Appendix I of RNTPC
Paper No. A/YL-KTN/994A

**APPLICATION FOR PERMISSION
UNDER SECTION 16 OF
THE TOWN PLANNING ORDINANCE
(CAP. 131)**

(a) Proposed use(s)/development 擬議用途/發展	Proposed Temporary Open Storage of Construction Materials for a Period of 3 Years and Associated Filling of Land (Please illustrate the details of the proposal on a layout plan) (請用平面圖說明擬議詳情)

(S.16 Planning Application No. A/YL-KTN/994)

Figure 1 – Site Location Plan
Figure 2 - Existing Drainage Plan
Figure 3 – Proposed Drainage System
Figure 4 – Catchment Plan

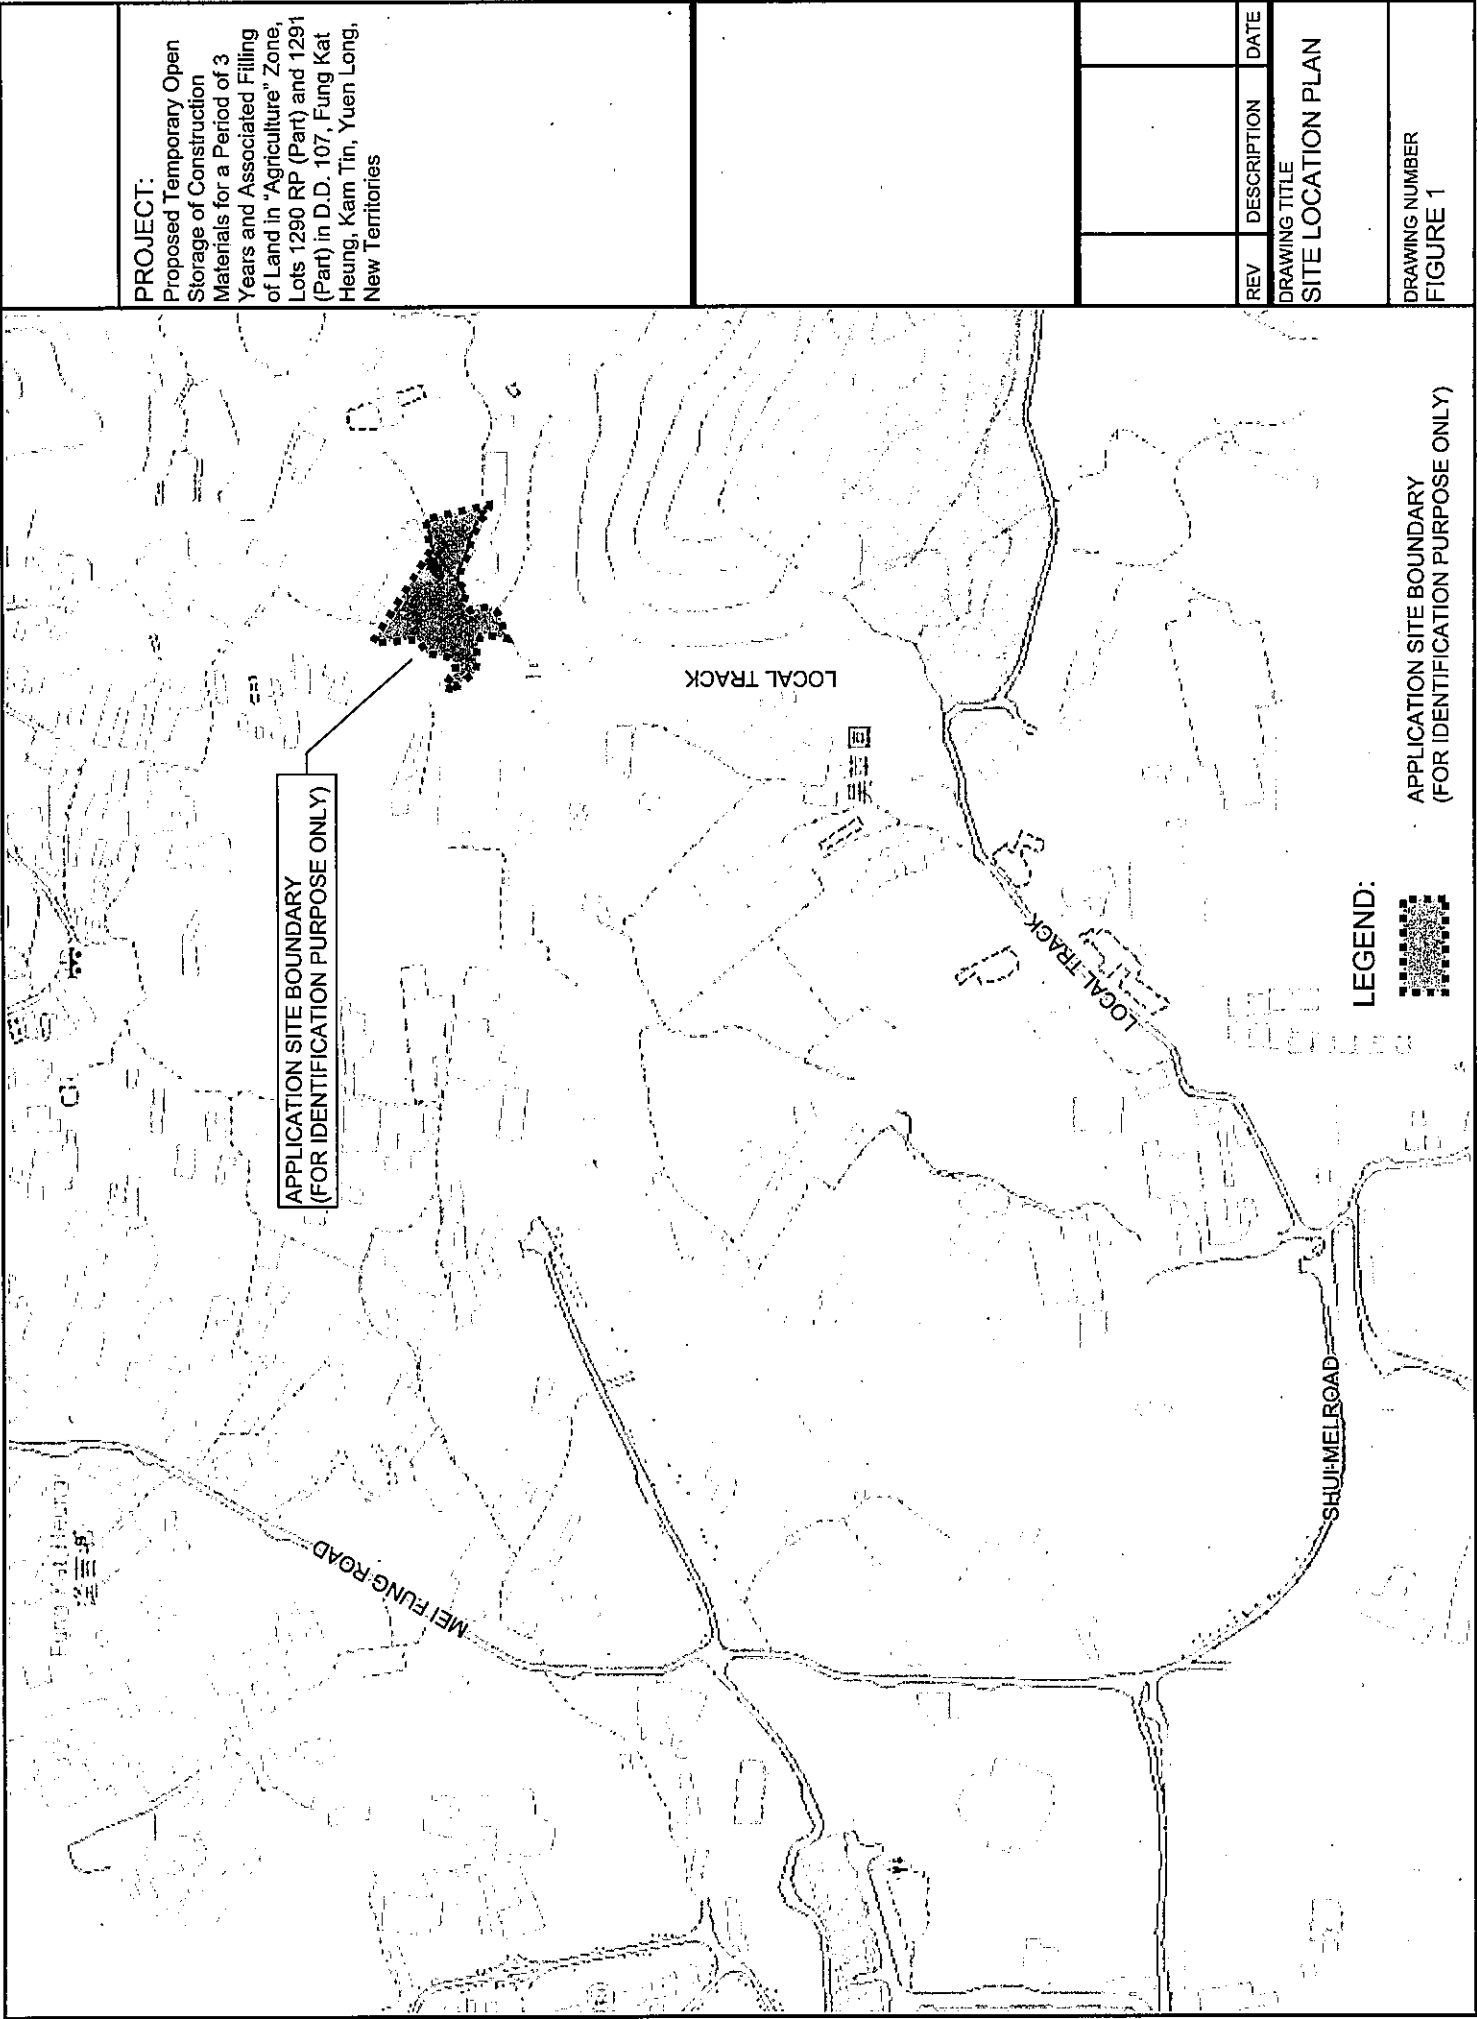
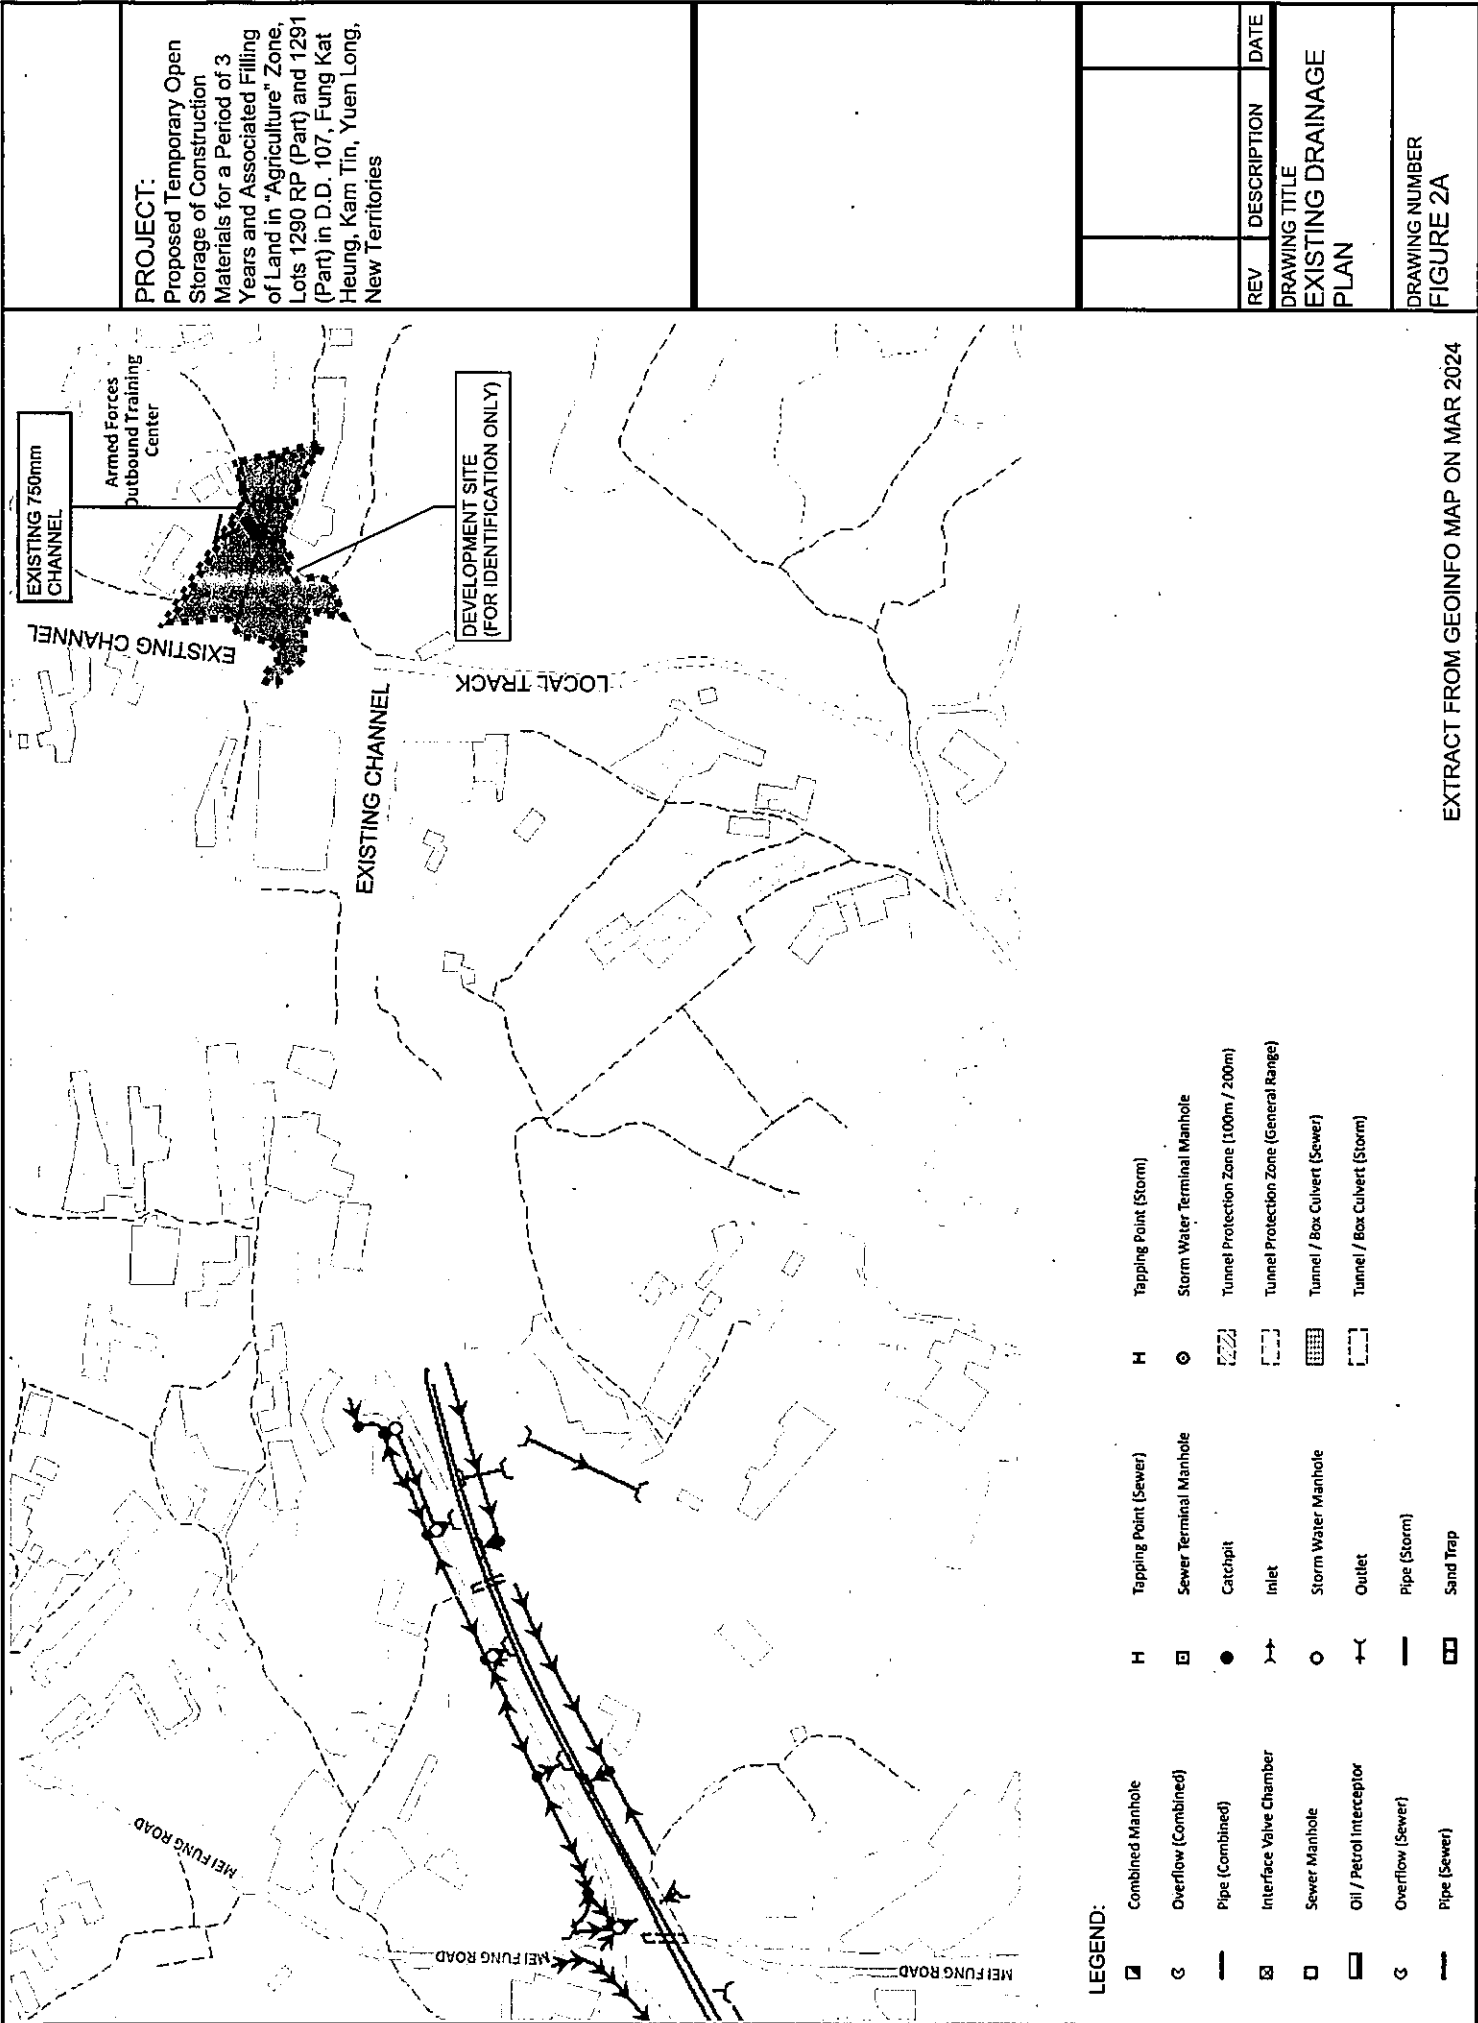
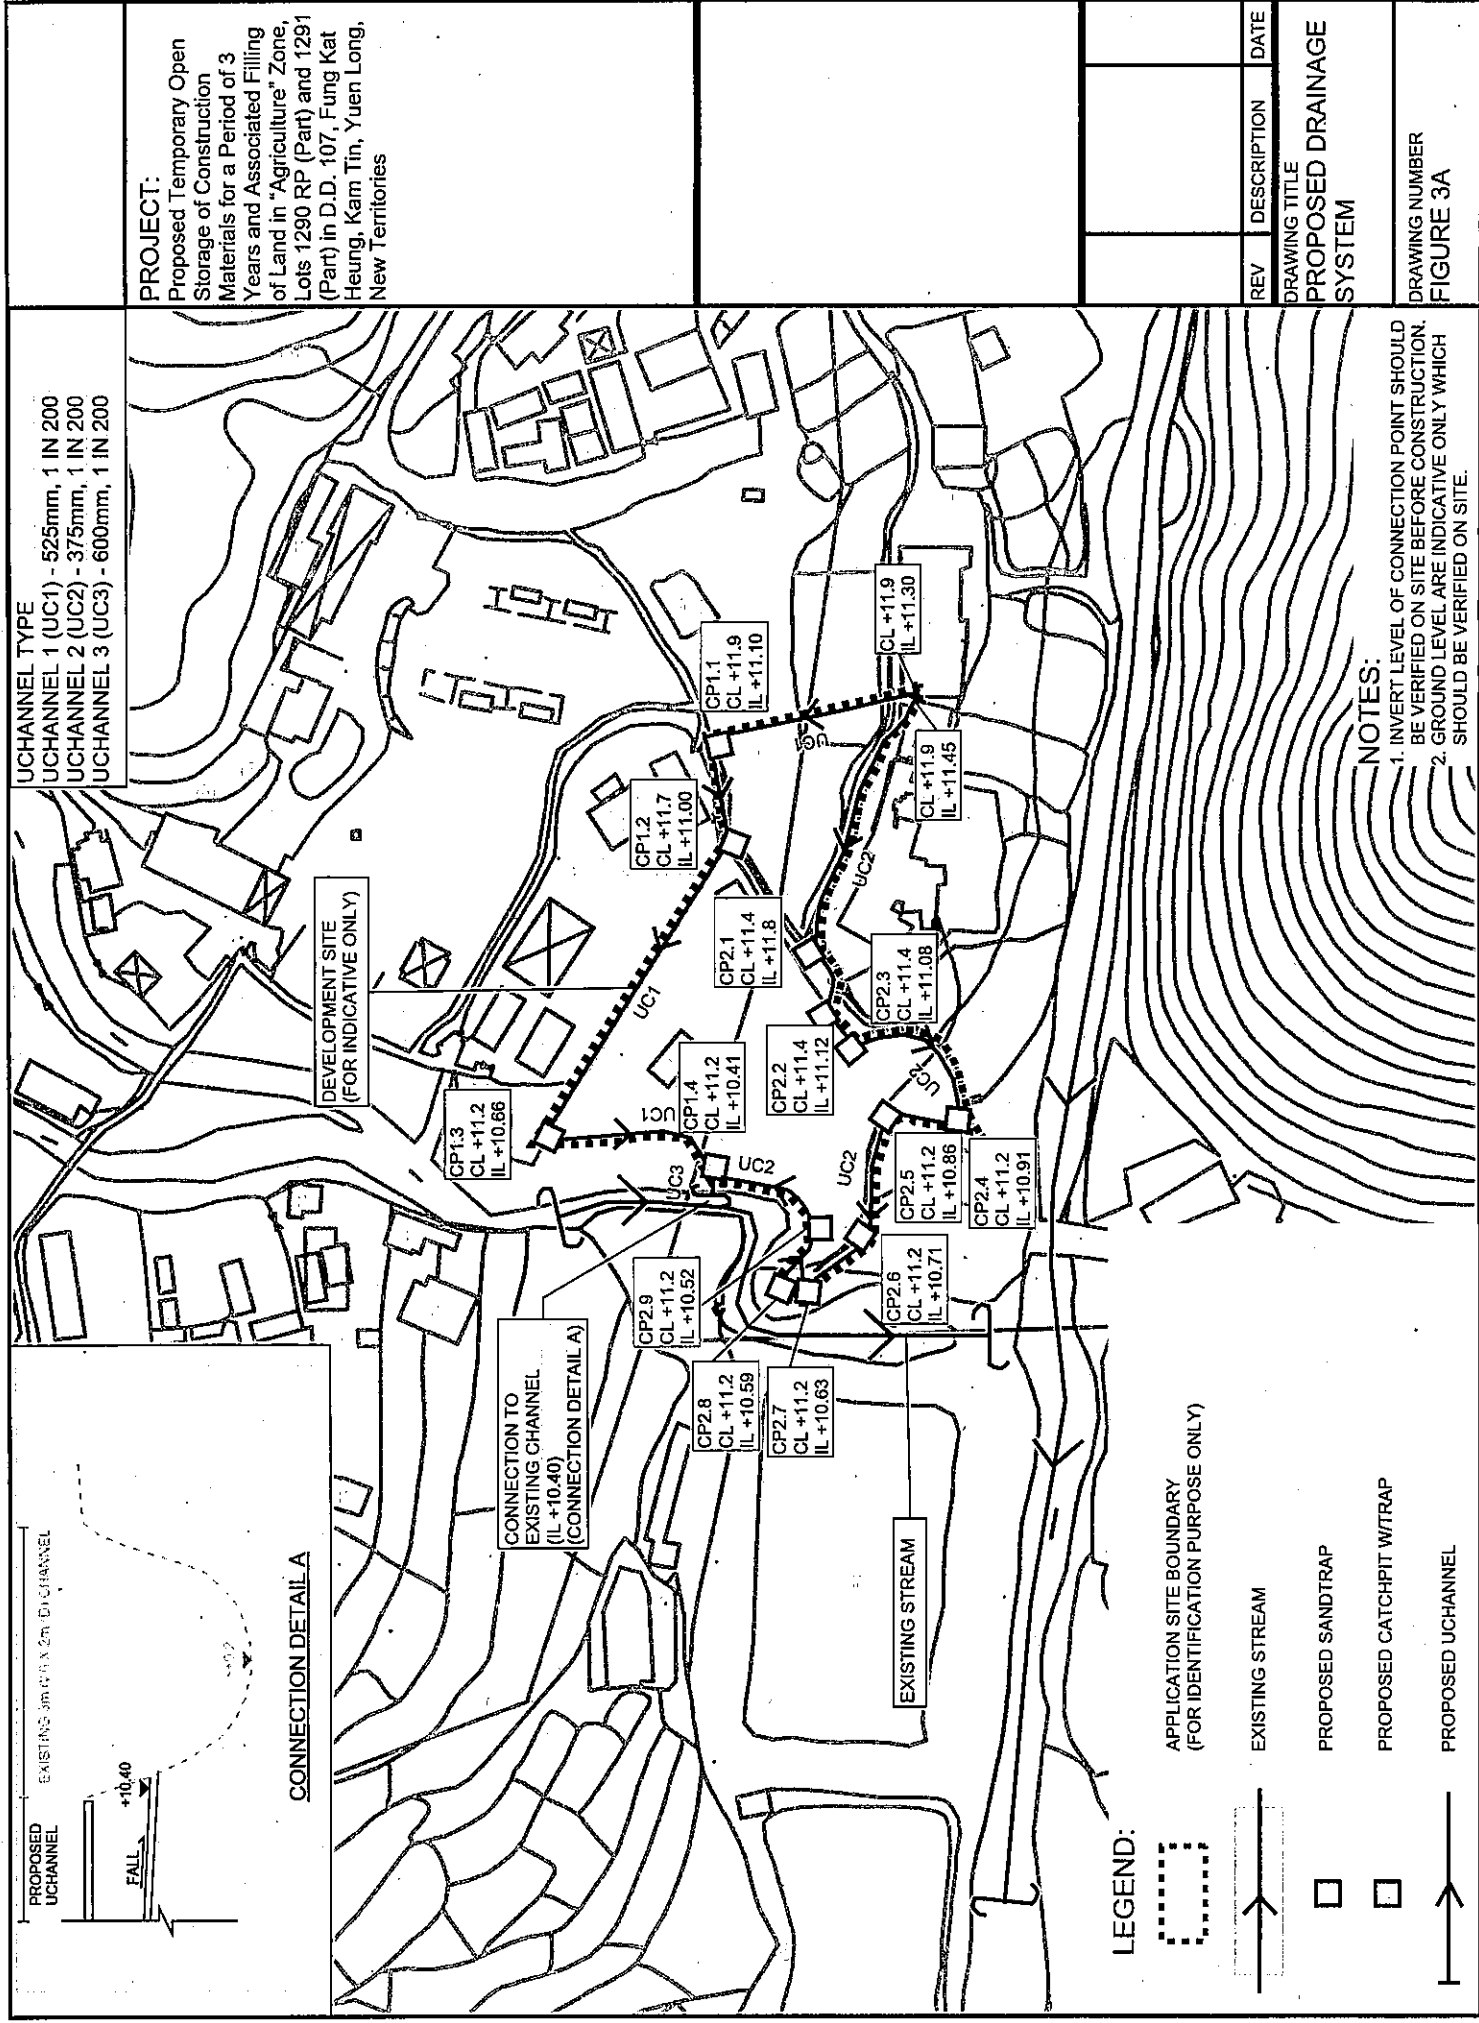
(a)	Please review and revise the proposed external catchment area as it appears should be larger according to existing topographical data.	Noted. Please refer to the updated catchment plan in Figure 4 of Annex I .

(b)	Please number the proposed catchpits as CP1, CP2...etc. for reference.	Noted. Please refer to the updated Figure 3 of Annex I .
(c)	The invert level of last catchpit should be higher than that of existing stream.	Noted. Please refer to the updated Figure 3 of Annex I .

(d)	The proposal should indicate how the runoff (the flow direction) within the site would be discharged to the proposed u-channel.	Noted. Please refer to the updated catchment plan in Figure 4 of Annex I .
